Memorandum of Understanding for Cirencester Sluice Gates - Questions Nov 2021

4. Mill pound overflow into the Daglingworth stream floodplain, the “Swan Lake” and Querns Springs.

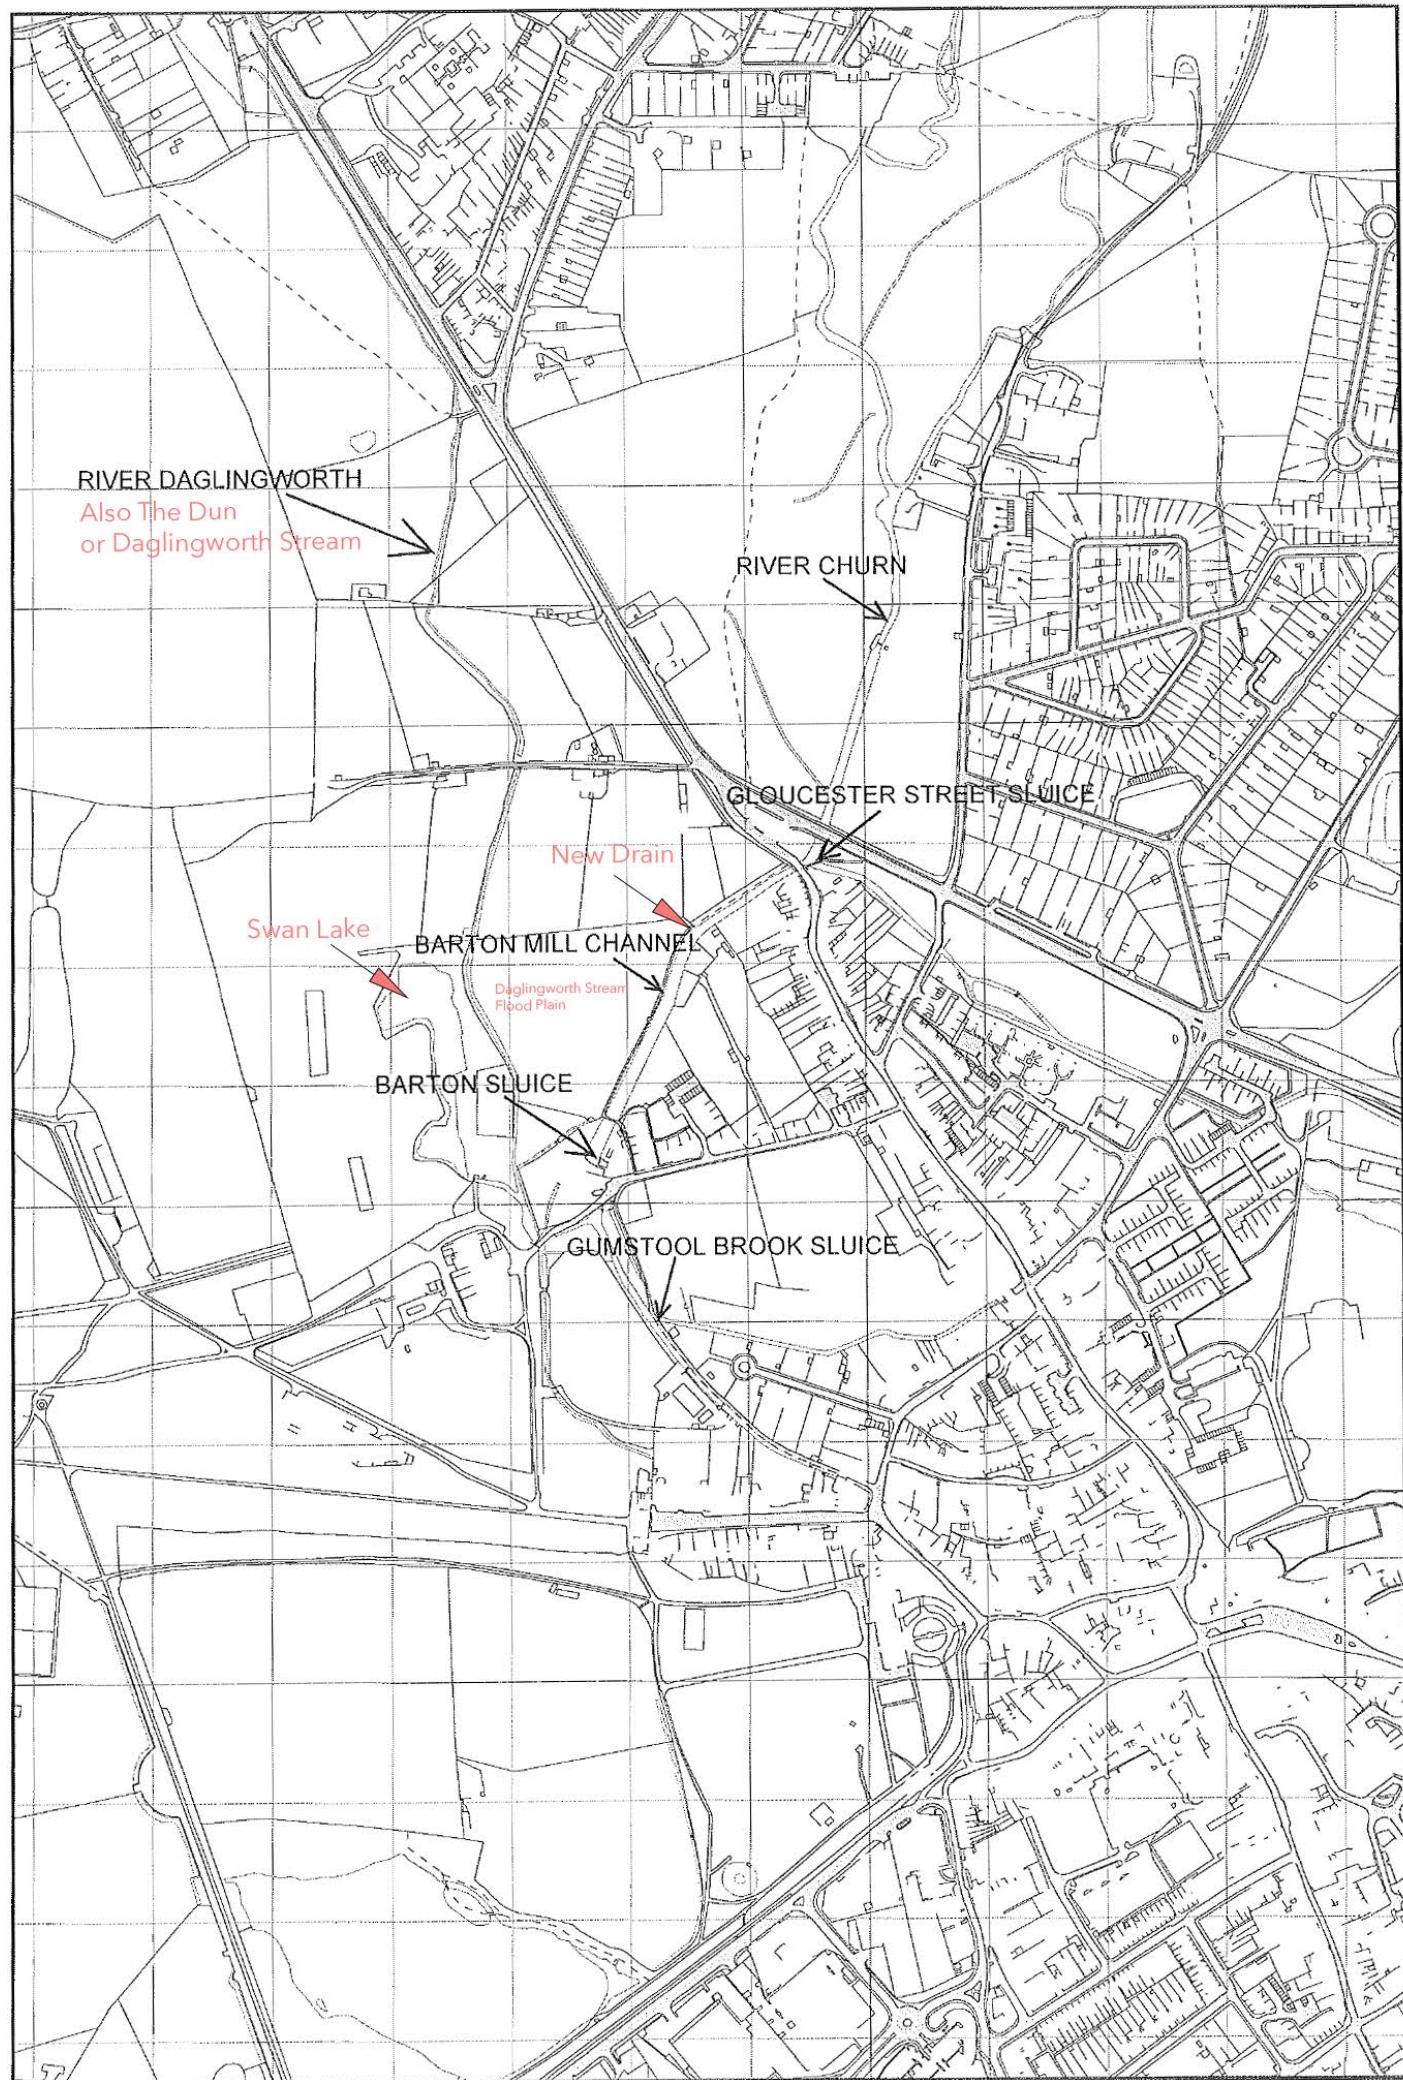
There is no mention of any of these in the MOU or their considerable effects?
